SCHEME:
Land at Pontymister, Risca

PLOT TITLE:
Proposed Model Extent Plan

From: Derrick, Richard <Richard.Derrick@cyfoethnaturiolcymru.gov.uk>
Sent: 18 September 2024 09:54
To: Martha Hughes
Subject: RE: 15679 - Land at Pontymister, Risca - Proposed Hydraulic Modelling Methodology

Appendix E 1D/2D Model Extent

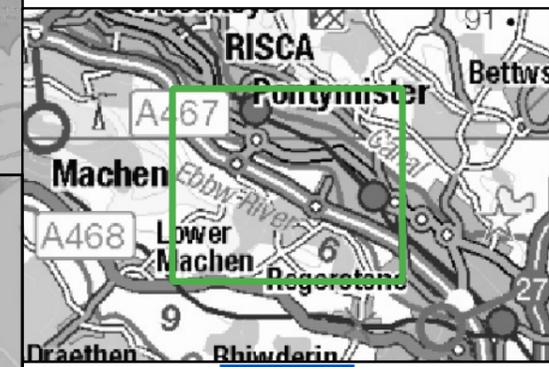
- Model extent - the upstream extent of the hydraulic model will be truncated to the confluence between the Ebbw River and the Sirhowy River. The downstream extent of the model is to be maintained as per the NRW model. See extent outlined below.

- 1) We are not aware of any pre-existing issues with the model
- 2) There is new LiDAR available flown between 2020 and 2022 which is available from [DataMapWales](#)
- 3) If the model is to be truncated then we would recommend carrying out sensitivity analysis on the downstream boundary.

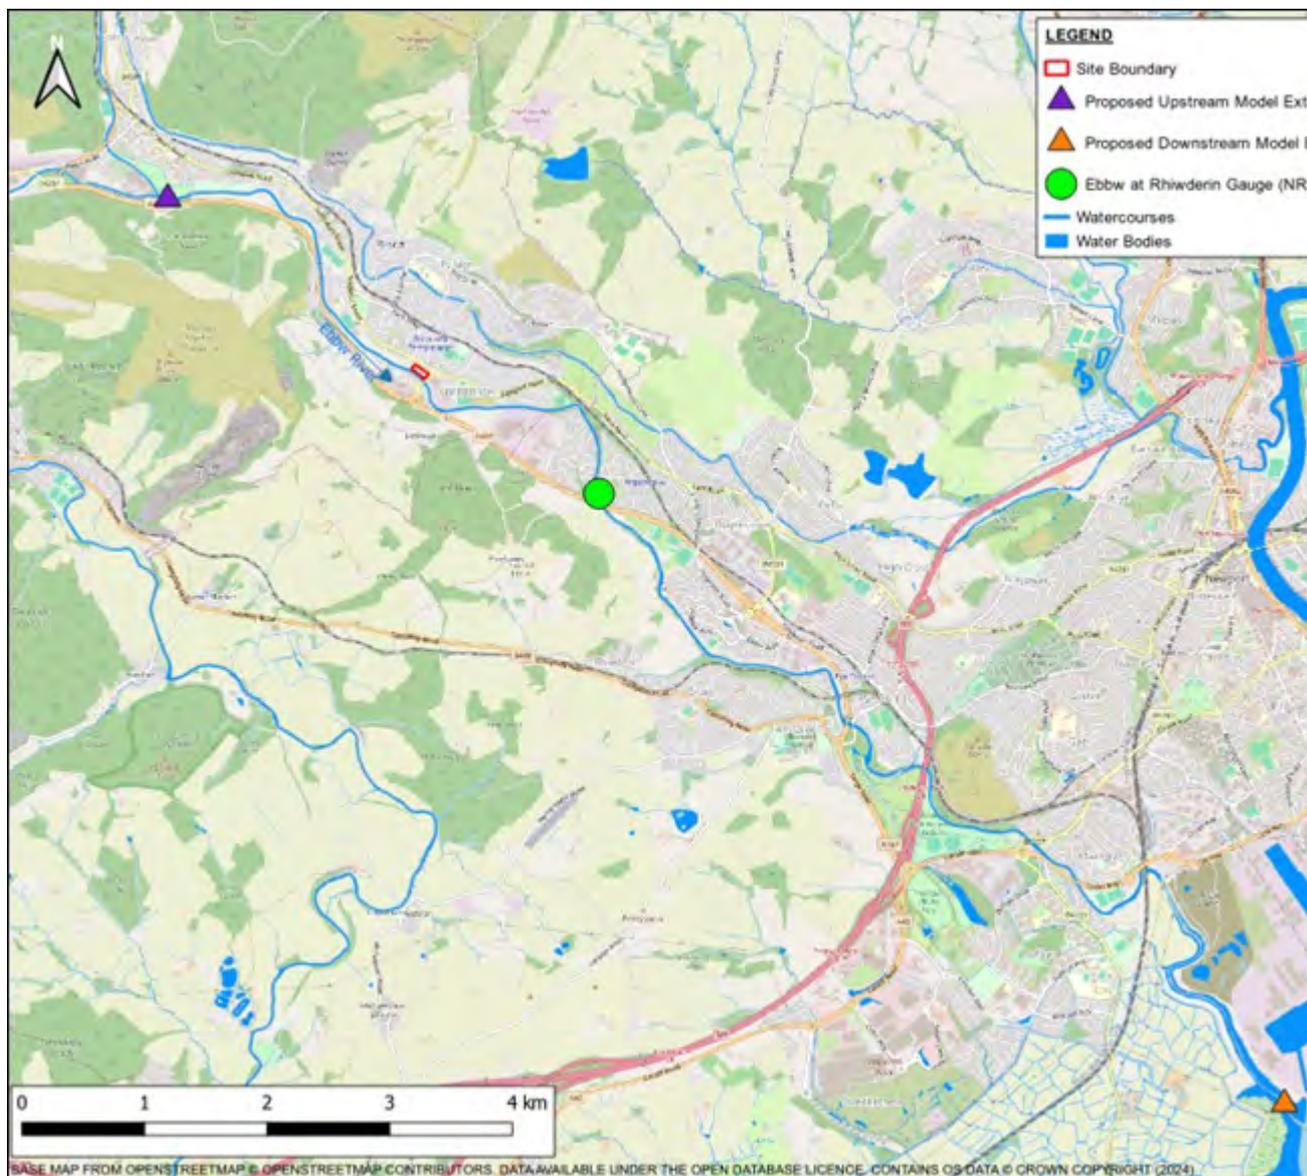
- Due to the locations of the upstream and downstream boundaries of the hydraulic model and the large catchment area (>200km²), a single inflow will be required for the hydraulic model.

Apologies for the delay in replying I've been on leave and am catching up on emails, our Hydrology team have confirmed that your methodology is suitable.
